<b>Subject:</b> <b>AT - VIBRATION AT 45-60 MPH DURING LIGHT ACCELERATION</b>	<b>Bulletin No:</b> 05-007/08
	<b>Last Issued:</b> 5/22/2008

2006-2008 RX-8 vehicles equipped with 6-Speed AT

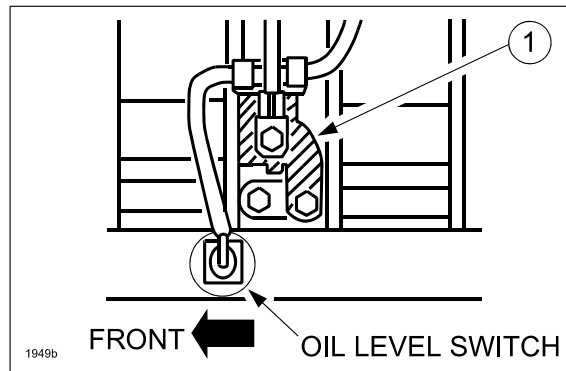
10. Replace wire bracket (1) on intermediate housing with modified one.  
**Tightening torque: 14-18 ft. lbf (19-25 N.m)**

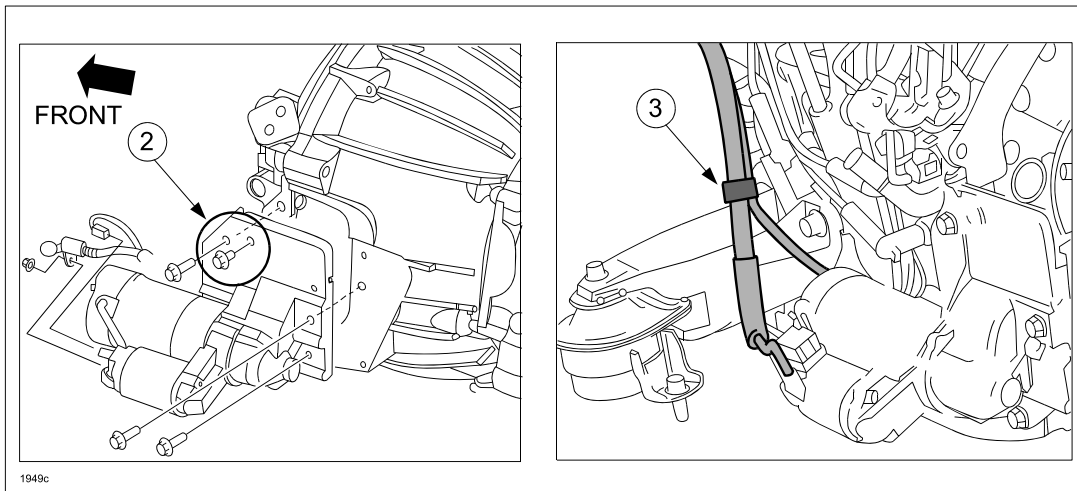
- Install supplied bolt (9979-60-812) into the extra mounting hole (2) using teflon tape or silicone sealant on the threads.  
**Tightening torque: 14-18 ft. lbf (19-25 N.m)**
- Use electrical tape to secure the ground wire to the starter wiring harness (3).
